**Uniform provisions concerning the approval of motor vehicles with regard to the Advanced Emergency Braking System (AEBS) for M<sub>2</sub>, M<sub>3</sub>, N<sub>2</sub> and N<sub>3</sub> vehicles**

## Industry draft proposals with purple text

**Figure 1:**  
**Left turn or right turn at the intersection**

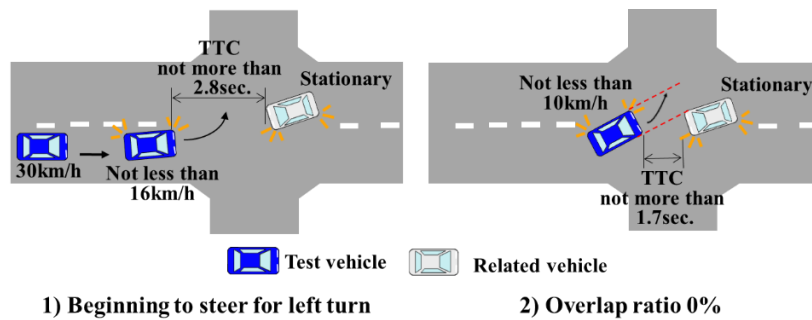
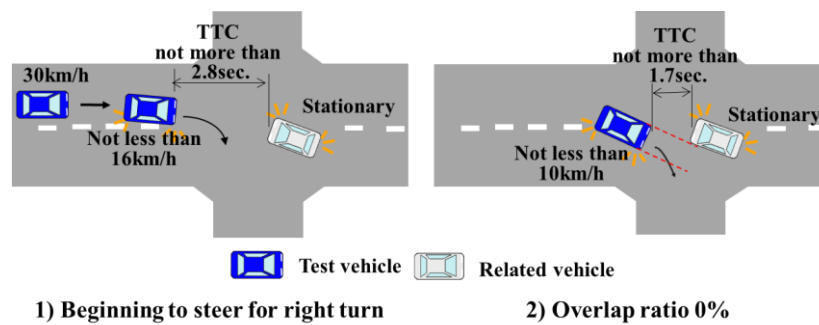
The blue car needs to be changed from passenger vehicle to large vehicle.

**Figure 2:**  
**Right turn or left turn of a forward vehicle**

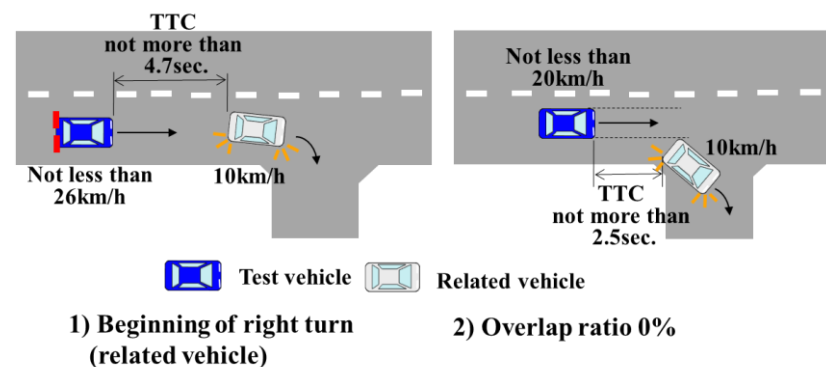
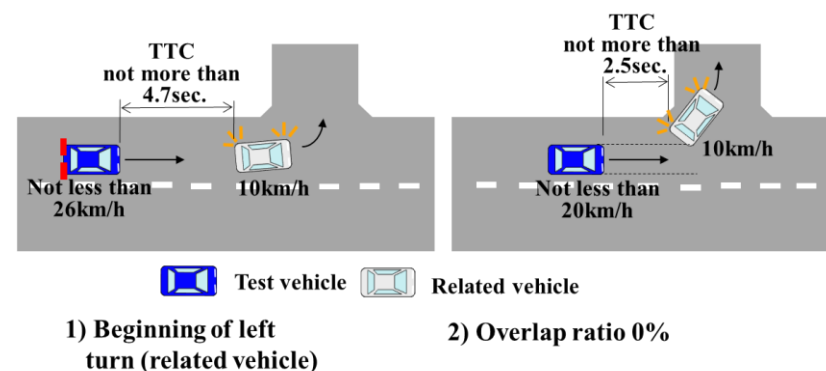
The blue car needs to be changed from passenger vehicle to large vehicle.

Figure 4:  
Lane change due to road construction

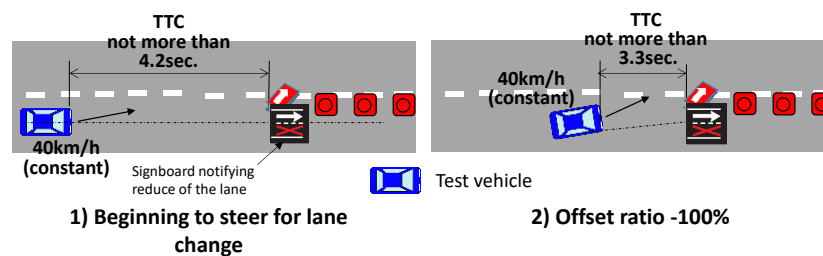
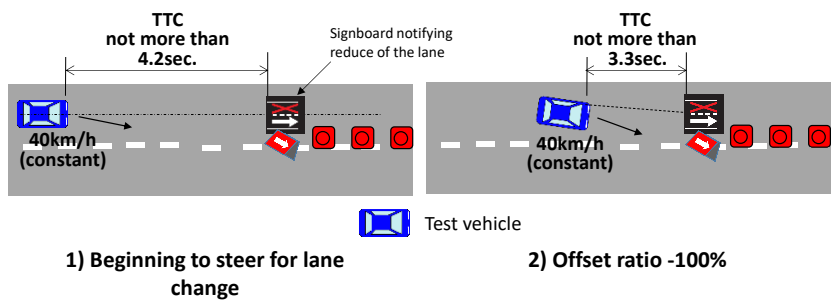
The blue car needs to be changed from passenger vehicle to large vehicle.
